PICkit 2 Hardware Updates

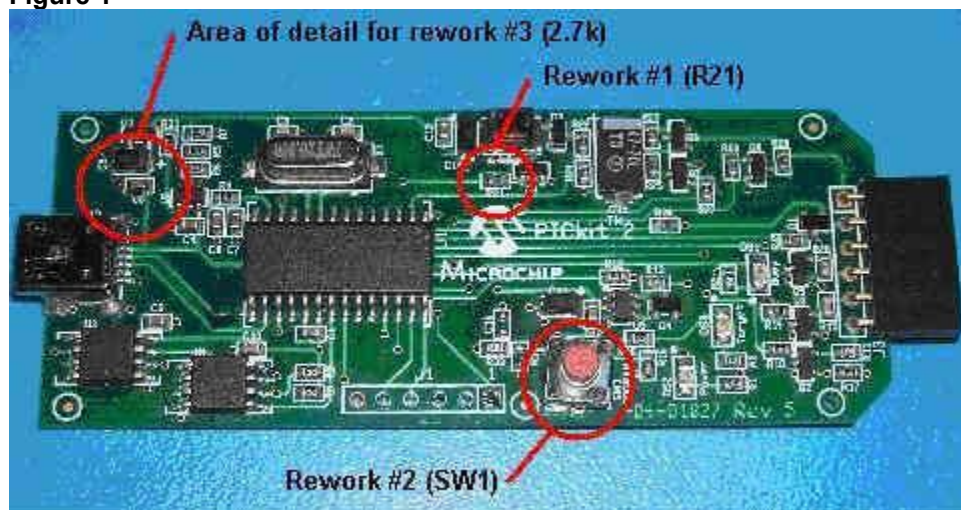
Update Rework #1
Purpose: Allows VPP charge pump to source more current. This is done for general robustness and to support upcoming parts that may require more VPP current.

1) Remove R21
2) Replace with 1k Ohm 5% 0603 resistor.

Figure 1

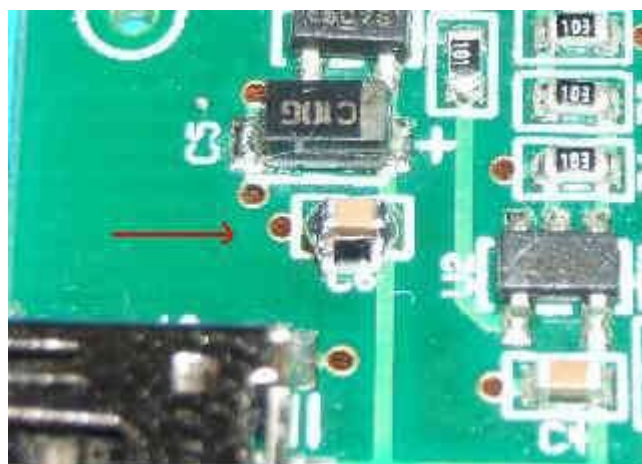
Update Rework #3
Purpose: Adding this resistor from +5V_USB to GND help prevent "unrecognized device" USB errors by bleeding capacitor voltage to ensure a proper POR.
See Figure 1 for area of detail. See Figure 2 for detail.
1) Add 2.7k Ohm 5% 0603 resistor across C6. Resistor may be placed on top of or next to C6.

Figure 3

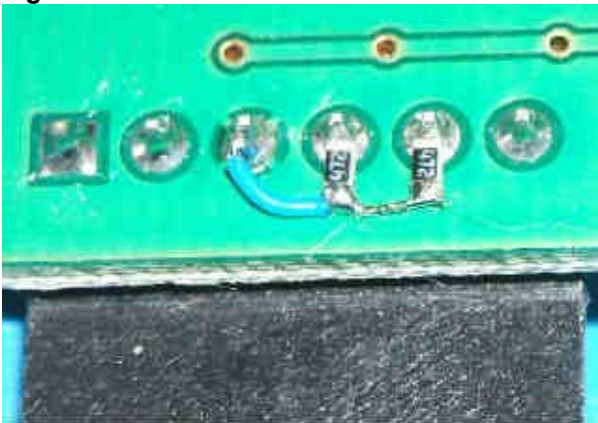
Purpose: This is the most important update. The pull-down resistors from PGC to GND and PGD to GND are necessary for reliable debugging using PICkit 2.

See Figure 3 for area of detail. See Figures 4 & 5 for details of 2 possible rework options.

Area of detail for rework #4 (4.7k)
